SERVICE BULLETIN

M-1142

2004 SERVICE LITERATURE UPDATE

To communicate updates to 2004 model year service literature.

Figure 1. Dyna Fuel Gauge Sender Wire Harness Routing

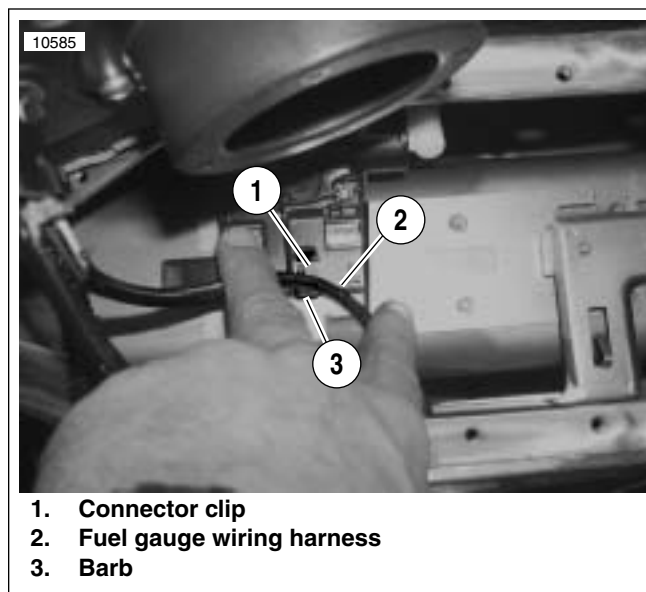
This routing is intended to keep the fuel gauge wiring from obstructing the fuel nozzle area when refueling.

See Figure 1. While servicing fuel sending unit or fuel pump on FXDI and FXDXI models, route fuel gauge wiring harness (1) through barb (2) on left side of connector clip (3) as shown. Do not install fuel pump connector in connector clip. Fuel pump connector should remain connected but unclipped.

Figure 2. Sportster Fuse Block

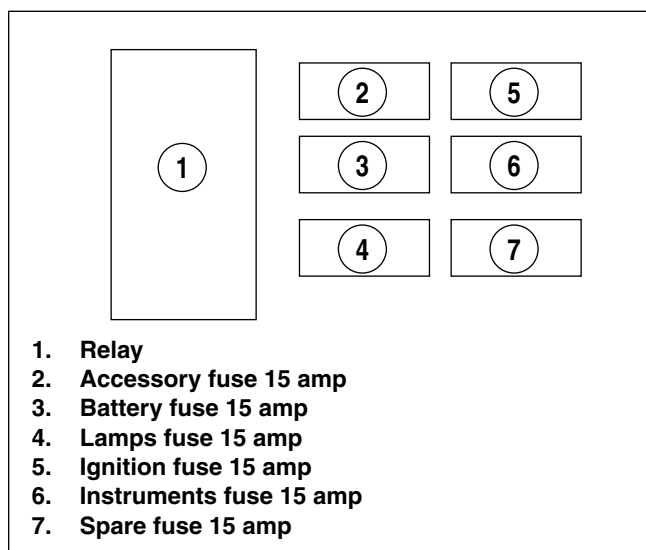
Part No.	Document / Section	Update / Correction
99468-04	Sportster Owner's Manual (print date of 08/03)/Fuse Replacement under Maintenance and Lubrication.	See Figure 2. Fuse Block - No. 6 is Instruments fuse No. 7 is Spare fuse
99468-04	Sportster Owner's Manual (print date of 08/03)/Rear Shock Absorber Preload Adjustment (All Models) under Controls and Indicators.	XL Custom models have five preload positions. XL 883 and Roadster have three preload positions.
99481-04	Dyna Service Manual/Assembly under Section 2.5 Rear Wheel. Torque Table at the beginning of Section 2.	Belt sprocket torque for both cast and laced wheels is 55-65 ft-lbs (75-88 Nm). Apply LOCTITE THREADLOCKER 271 to fasteners before installation
99483-04	Touring Service Manual/Bottom End Overhaul in Section 3: Engine	Cam cover torque is 90-120 in-lbs (10-14 Nm)
99947-04	Predelivery & Set-up Instructions (Sportster Models)/Tires under Front and Rear Tires.	Front tire pressure for both solo rider and rider/passenger is 30 PSI/207 KPA.
